SHOP DOPE

No. 356

June 1, 1955

TRANSMISSION GEAR INFORMATION

C/S 3rd Gear
35709-54

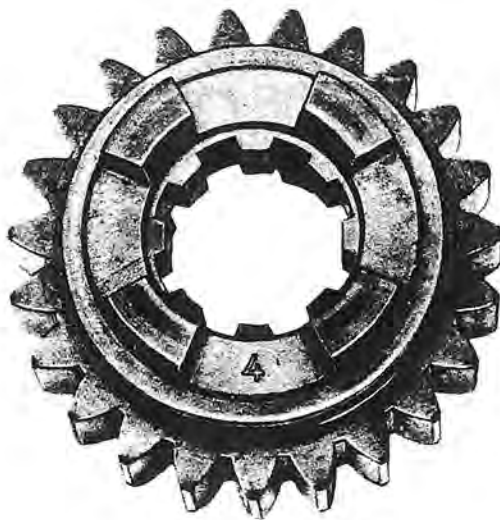
As a result of changes in material and heat treatment, the above two gears now in new motorcycle production and furnished on parts order are much huskier gears than were available earlier.

The later, huskier gears are identified by the numeral 4 stamped between the driving dogs. Disregard other numbers that may be found stamped elsewhere on the gears.

The first huskier gears produced have twenty four teeth; later the number of teeth will be reduced to twenty three. However, gear pitch diameter stays the same whether twenty-three or twenty-four teeth, and therefore one gear can be replaced with the other. Gears identified by the numeral 4, whether twenty-three or twenty-four teeth, are OK to use.

The new gears went into new motorcycle assembly starting with number 55KH 1706. A few lower numbered motorcycles have the new 35709-54 C/S 3rd gear, but not the new 35297-54 M/S 2nd gear.

SERVICE RECOMMENDATIONS - Use only the later gears for future servicing. Inspect your new stock of the above described gears. (Look closely, as the identifying 4 is not always easy to see.) If you find that you have none of the later gears, order some. Only the later gears are furnished on parts order. New, earlier gears you have on hand can be returned for exchange or credit.

Whenever a KH, KHK or KHRM engine below the number mentioned must be opened up for any kind of service, inspect these two gears. If either or both are found not marked with the numeral 4 as shown above, replace with the later gears.
